# Rezoning Transportation Analysis

Petition Number: 2021-168

## Revision Log:

Date	Description
11-19-2021	First Review (KP)
12-20-2021	Second Review (KP)

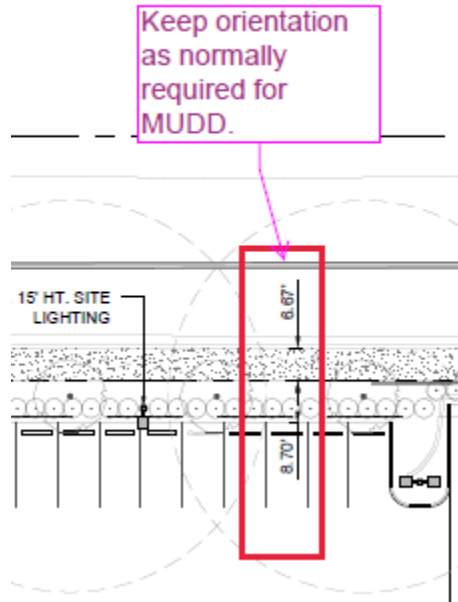
### 3. ~~Right-of-way:~~

- a. ~~**Berryhill Road:** Revise the site plan and conditional notes to commit to dedicated 36-foot of right-of-way from the existing road centerline, in accordance with CLDSM U-07 (Local Collector Street).~~
- b. ~~**State Street:** Revise the site plan and conditional notes to commit to dedicated 36-foot of right-of-way from the existing road centerline, in accordance with CLDSM U-07 (Local Collector Street).~~

~~The site plan shall label and dimension the dedicated right-of-way from the existing centerline of each road.~~

~~**Comment Resolved as a result of 12-08-2021 Coordination Call with Petitioner:** 25.5-foot of right-of-way dedication to be provided.~~

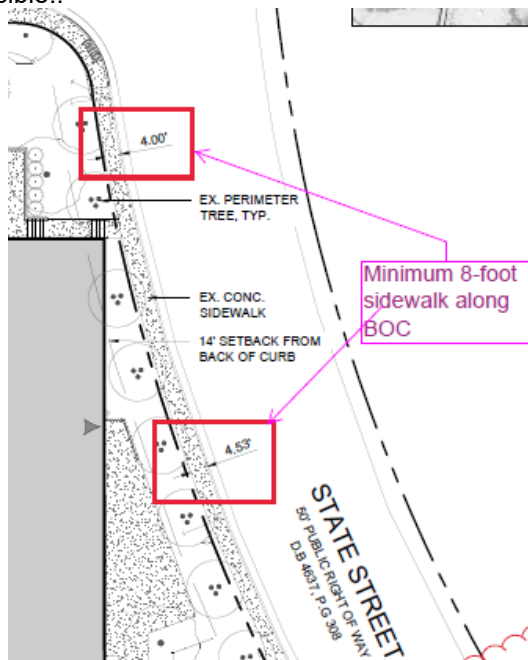
5. ~~Revise site plan and conditional note(s) to commit to construct a minimum 8-foot sidewalk along the site's frontage of State Street and Berryhill Road where the sidewalk is located at the back of curb. Additionally, the sidewalk width will be maximized where the existing building(s) or other site constraints inhibit an 8-foot sidewalk. These location(s) and sidewalk width(s) will be subject to approval by CDOT during permitting. Lastly, remove conditional note 2.b~~

~~Comment Resolved as a result of 12-08-2021 Coordination Call with Petitioner:~~ Sidewalk will be maximized as much as possible.

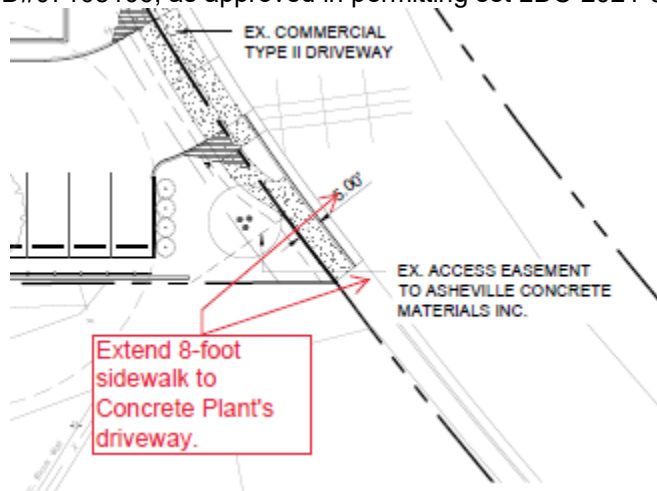
6. ~~Revise the site plan and conditional notes by showing the driveway location associated with Asheville Concrete Materials, PID#07108106, as approved in permitting set LDC-2021-00081. This driveway shall not be affected by any improvements associated with this site.~~

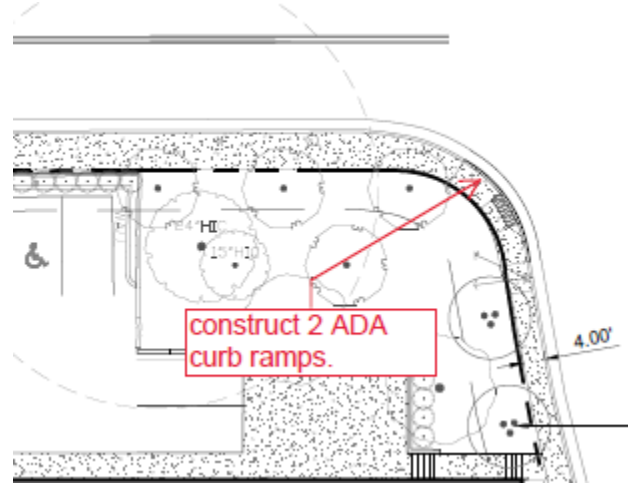
7. ~~Revise the site plan and conditional notes by committing to connect the 8-foot sidewalk, located at the back-of-curb along the site's frontage of State Street, into the driveway associated with Asheville Concrete Materials, PID#07108106, as approved in permitting set LDC-2021-00081.~~
